TRC AGENDA

**CITY OF DELAND
THURSDAY SEPTEMBER 21, 2023 AT 1:30 P.M.
CITY OF DELAND TRC MEETING ROOM
DELAND, FLORIDA**

**CITY OF DELAND
TECHNICAL REVIEW COMMITTEE MEETING
MEETING MINUTES
THURSDAY, AUGUST 17, 2023 -1:30 P.M.
CITY HALL**

City of DeLand
CSB23-160
COASTLINE LOFTS

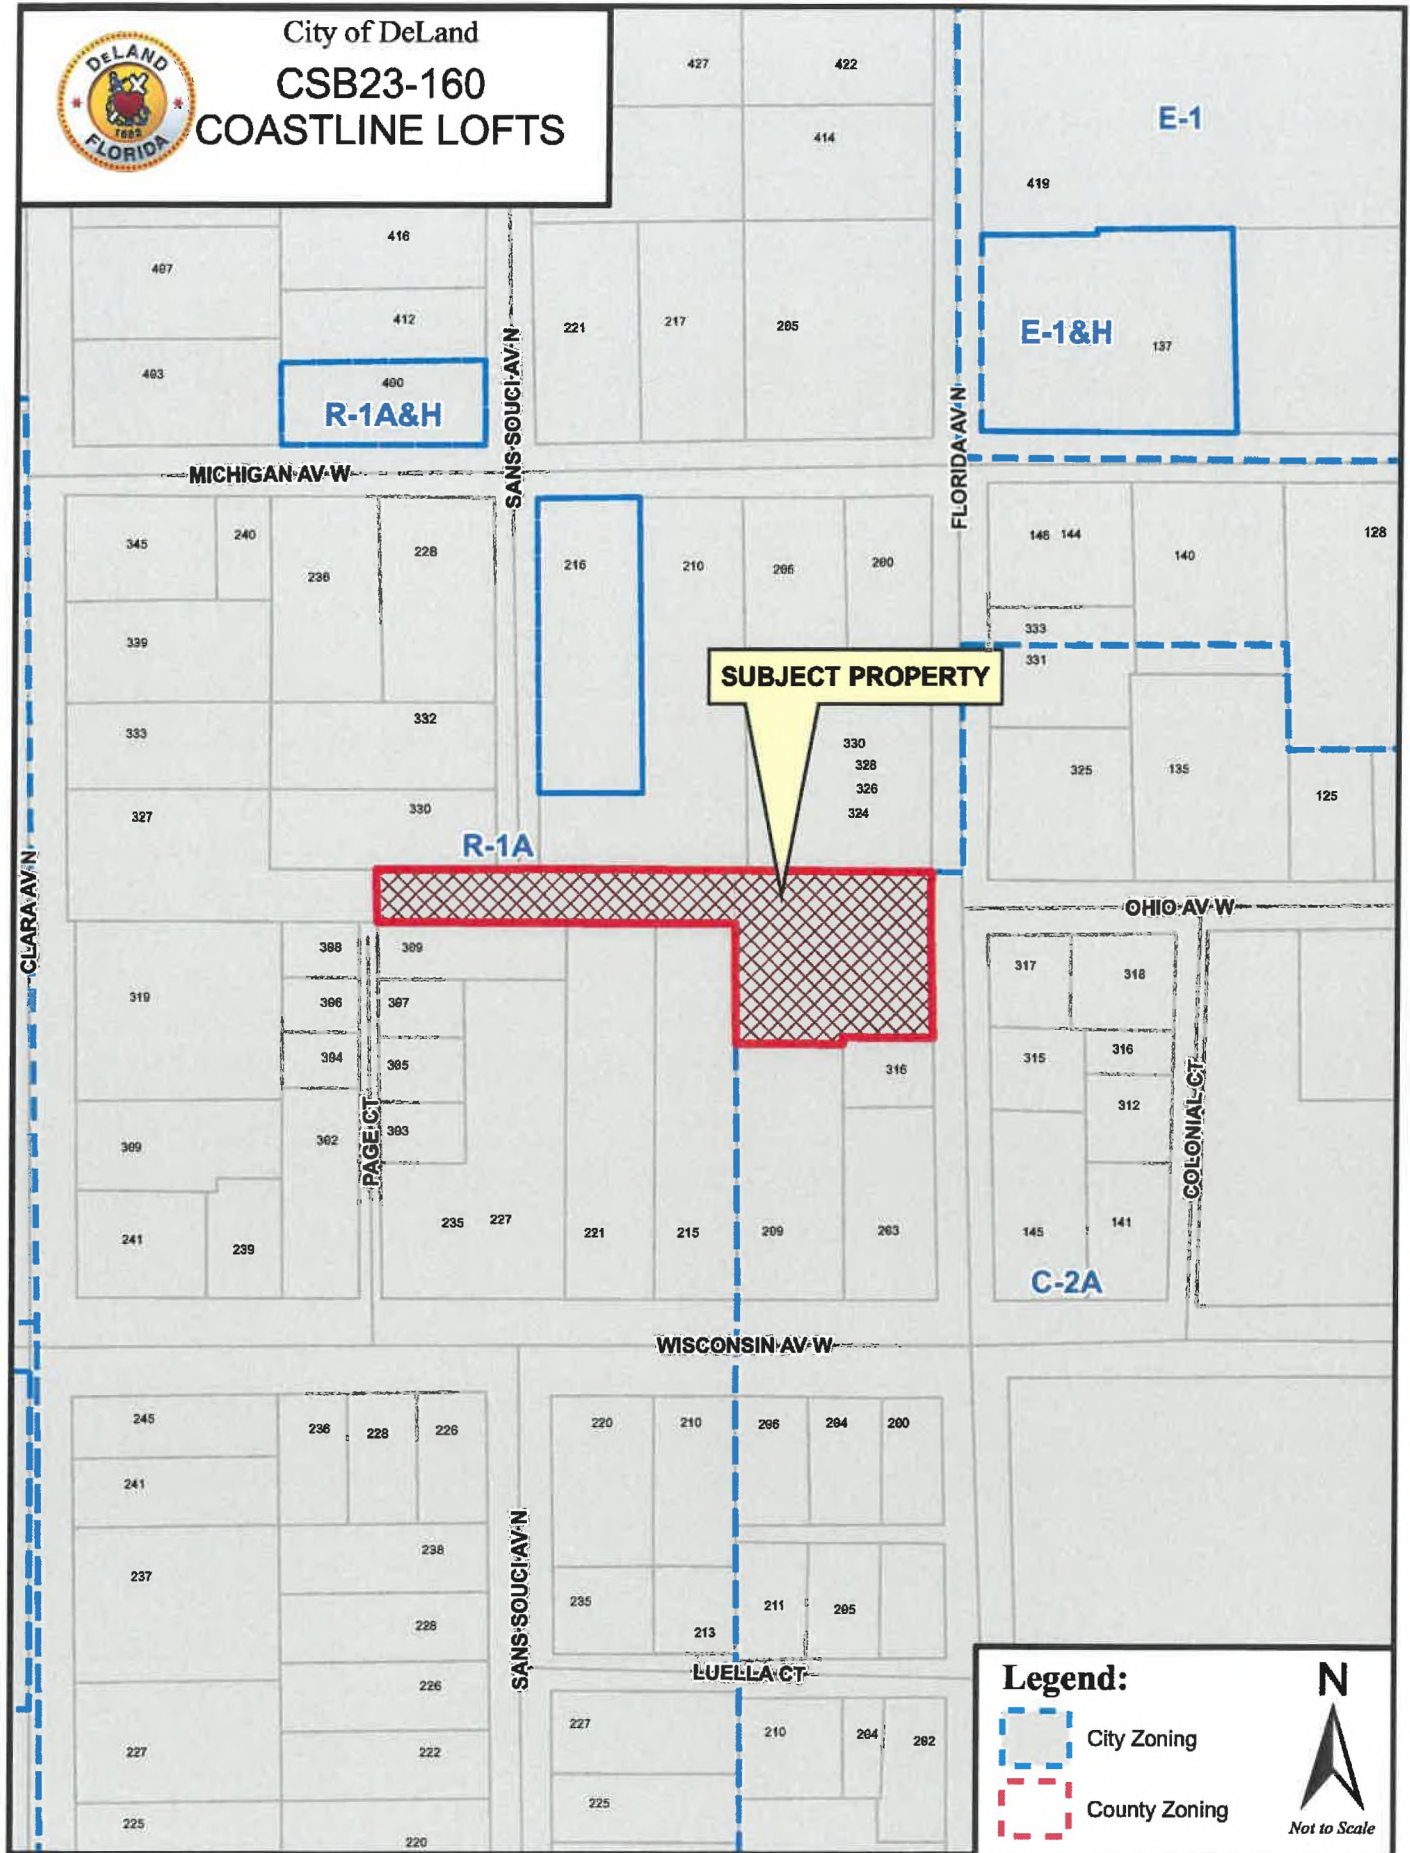
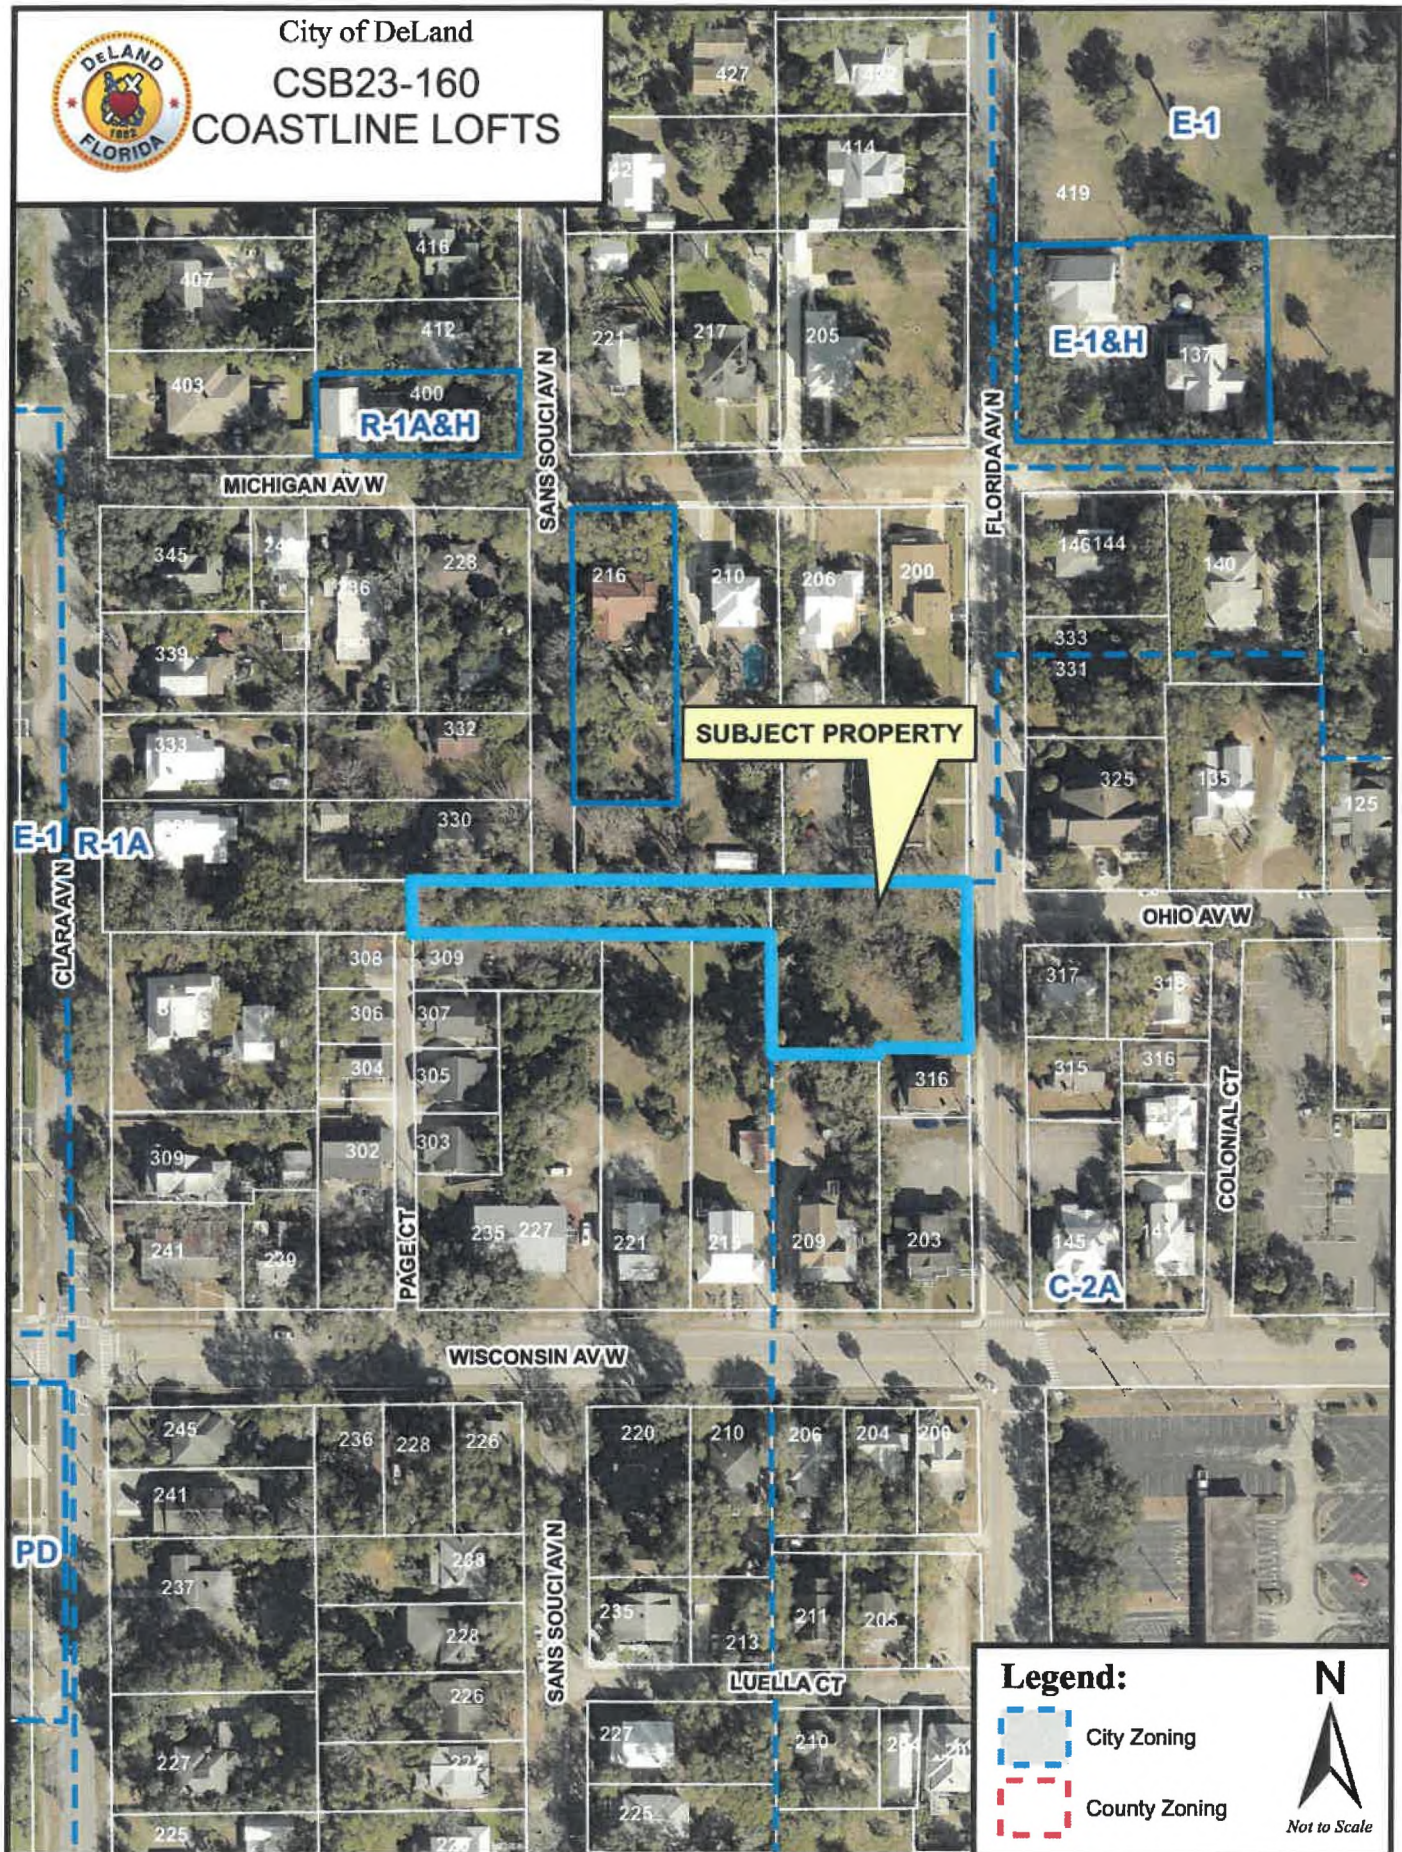
Discipline	Status	Details	Attached To	Created By	Last Updated By	Modifications Required
General issues						
Planning	Draft	• Explain why only one of the owners name is included • Include the date of the survey • Include the acreage with legal description • Specify the use of the land i.e. Tract A - Common area, Tract B - lofts		Belinda Collins	Belinda Collins	Yes

City of DeLand
MS23-181
BOUNDARY MINOR
SUBDIVISION

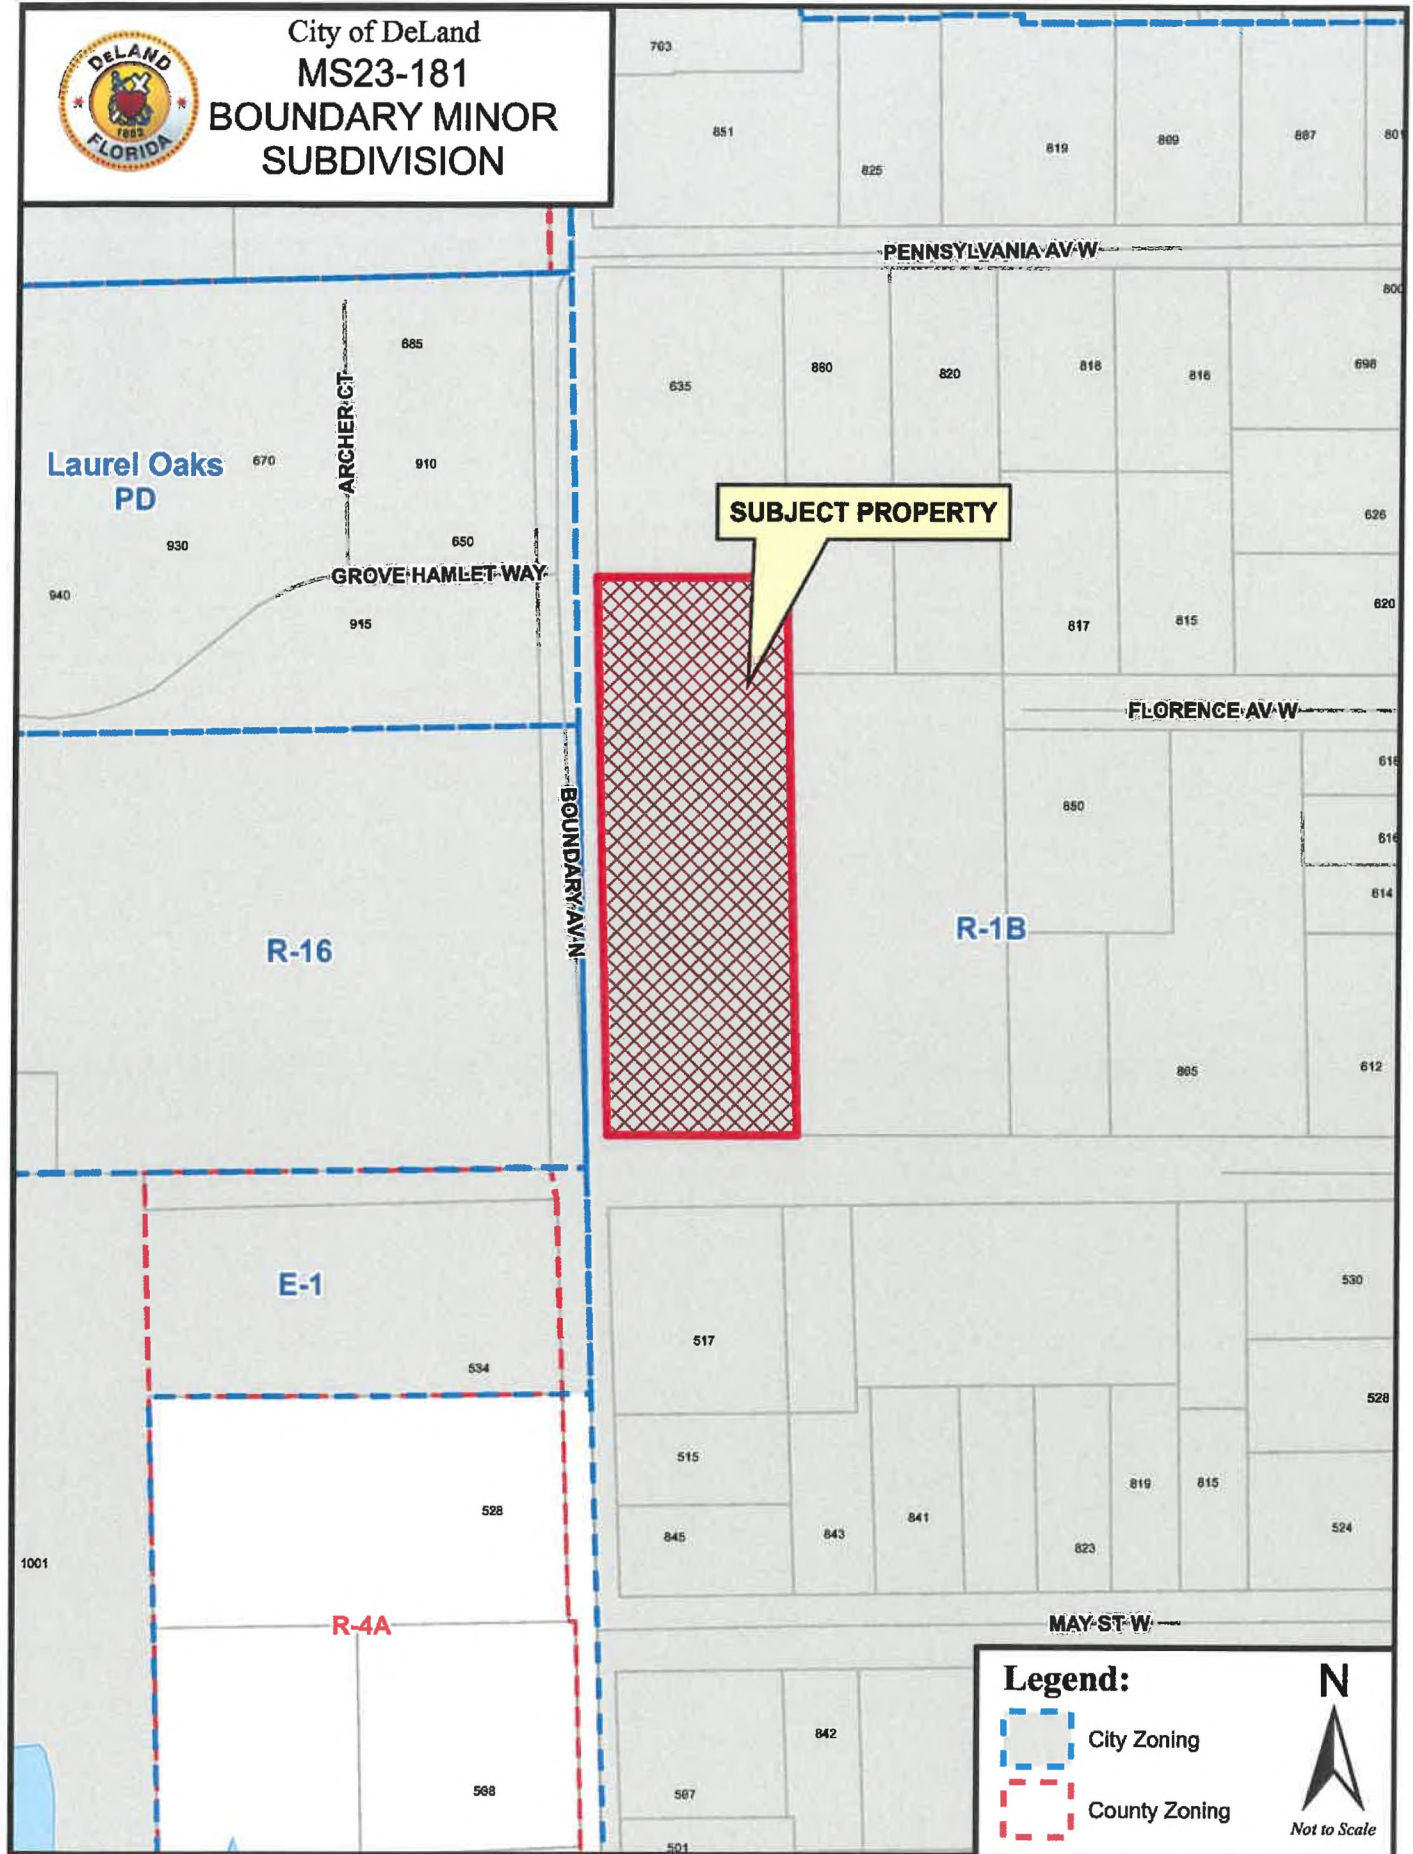
Discipline	Status	Details	Attached To	Created By	Last Updated By	Modifications Required
General Comments						
Engineering	Draft	1. Per Volusia County LIDAR Map, this site drains from NW to SE section of the site. Please provide the following information in Plot Plan for Building permit. A) Establish FFE for each lot. Per City LDC, FFE shall be a minimum of one foot above the center line elevation of the adjacent roadway. B) Provide swales at the rear of each lot to detain stormwater runoff from impervious areas (Roof/Driveway). C) Since stormwater runoff drains toward rear of the property, a Type C Lot Grading will be appropriate. Existing and proposed spot grade elevations need to be shown on Plot Plans. D) Concrete apron within the right-of-way area needs to be 6" in thickness/3000 PSI.		Ray Bahrami	Ray Bahrami	Yes
Forestry	Draft	Tree Survey A complete tree survey of all protected trees 6" DBH and larger will need to be submitted when you submit for a building permit.	Tree Survey of proposed Lots 1, 2 and 3.pdf	Kit Dennis	Kit Dennis	Yes

Planning	Draft	Combined Survey Please show the proposed lots together on one survey.		Samuel Nelson	Samuel Nelson	Yes
Planning	Draft	Volusia County ROW Use Permit This portion of N. Boundary Ave is maintained by Volusia County. Please verify that a ROW use permit will be able to be obtained for each driveway.	XXXX N BOUNDARY AVE (W HALF BLK 90 PARENT PARCEL) BNDY.pdf	Samuel Nelson	Samuel Nelson	Yes
Planning	Draft	Alley I was unable to locate the public alleyway shown on the northern end of the parcel, please verify the location.	XXXX N BOUNDARY AVE (W HALF BLK 90 PARENT PARCEL) BNDY.pdf	Samuel Nelson	Samuel Nelson	Yes

Discipline	Status	Details	Attached To	Created By	Last Updated By	Modifications Required
Planning	Draft	Building Envelopes Please show the proposed building envelope for each lot and verify that they meet R-1B standards.		Samuel Nelson	Samuel Nelson	Yes
Planning	Draft	Electric Service Please verify that electric services are available to the proposed lots.		Samuel Nelson	Samuel Nelson	Yes
Utilities	Draft	Utility Lines / Project Narrative 1. Make sure that they proper separation distance between the water and sewer services is provided for proper clearance. 2. FDEP drawing and submittal is required for sewer line install. As built needed after install. 3. Need to show utility specs for water and sewer. 4. Manhole must be cored and properly booted for connection to existing structure. 5. A Utility Service Agreement will be required. City will draft and send once final plans approved. 6. Is the proposed line to remain private and if so who pays for repairs or unclogs?		Jim Ailes	Jim Ailes	Yes
